**REGULAR MEETING OF THE PLANNING BOARD
WEDNESDAY – FEBRUARY 24, 2016
7:30 PM
CITY COMMISSION ROOM
151 MARTIN STREET, BIRMINGHAM**

SUBJECT: Final Site Plan Review for 1193 Floyd Street

TRASH ENCLOSURE DETAIL

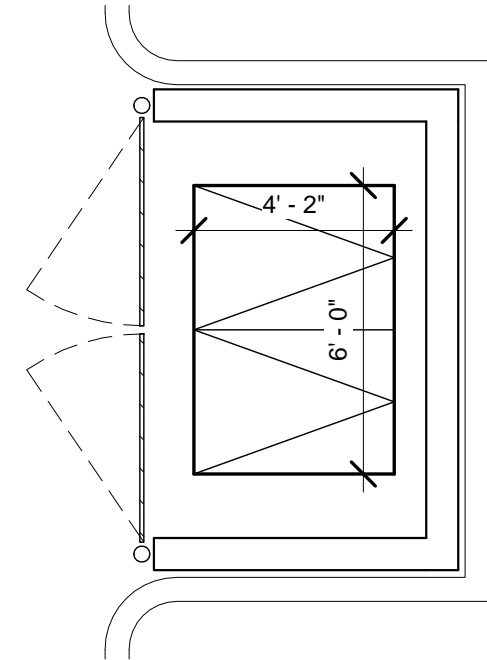
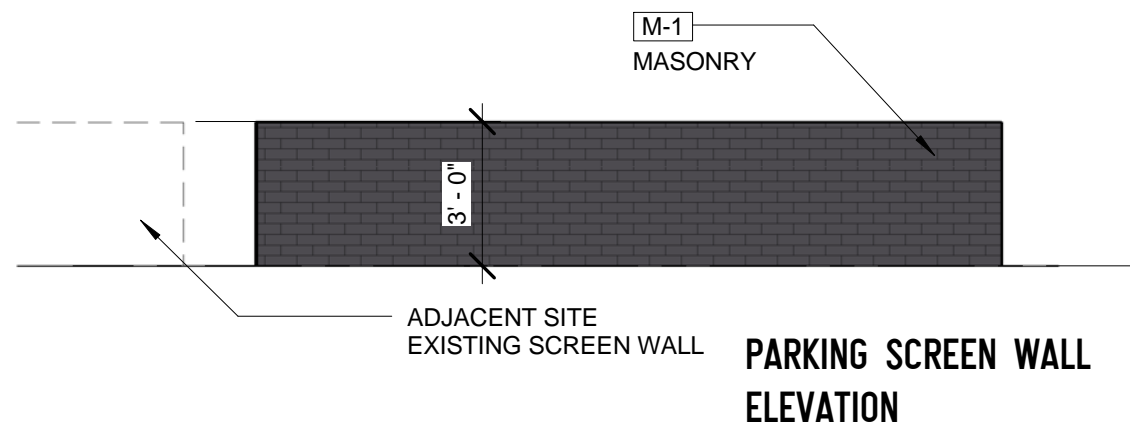
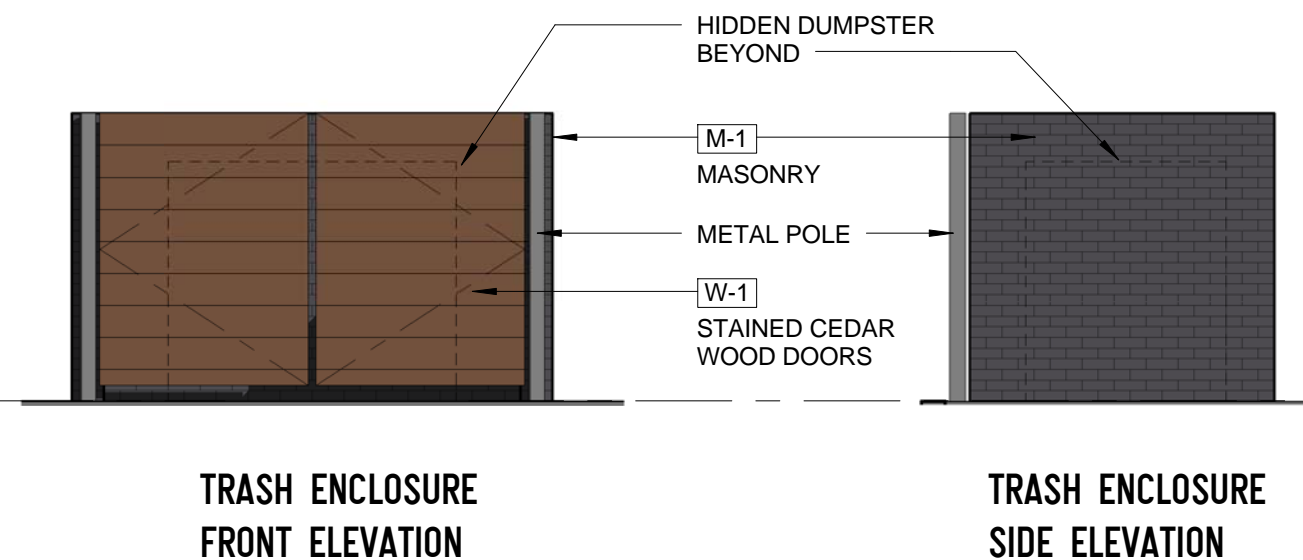
- 3.1 Dumpster Screening – The applicant is proposing a dumpster enclosure along the eastern property line. The applicant has proposed a masonry screen enclosure with stained cedar wood swing doors. However, the dimensions of the enclosure are not indicated on the plans. **The applicant must provide plans that specify a minimum 6' enclosure wall, which is in accordance with Article 4; section 4.53 C (7) of the Zoning Ordinance.**

1. Applicant provide evergreen plantings in lieu of the lilac trees to fully screen the transformer and all ground-mounted mechanical;
2. Add 4 additional street trees to be planted in the general area of the site and/or St. James Park as approved by City staff; and
3. Provide revised plans that indicate that the dumpster enclosure is 6' high or obtain a variance from the Board of Zoning Appeals.

PRODUCT SPECIFICATIONS

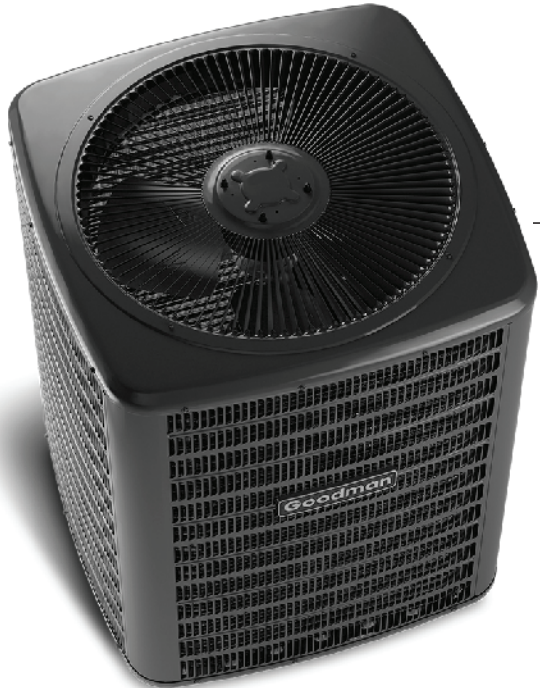
- 3.3 Mechanical Equipment Screening – The applicant proposes to have no rooftop mechanical equipment, therefore no rooftop screening is required. The plans propose 4 ground-mounted 27.5" tall Goodman GS13 Split System Air Conditioner units and a 48" tall transformer along the east exterior wall. The plans indicate that the AC units and transformer will be screened from the southern view with two (2)

Miss Kim Lilac trees, which are deciduous trees. Deciduous trees are not recommended for screening purposes. **The Planning Division recommends that the applicant be required to select an evergreen planting in lieu of the lilac bush.**
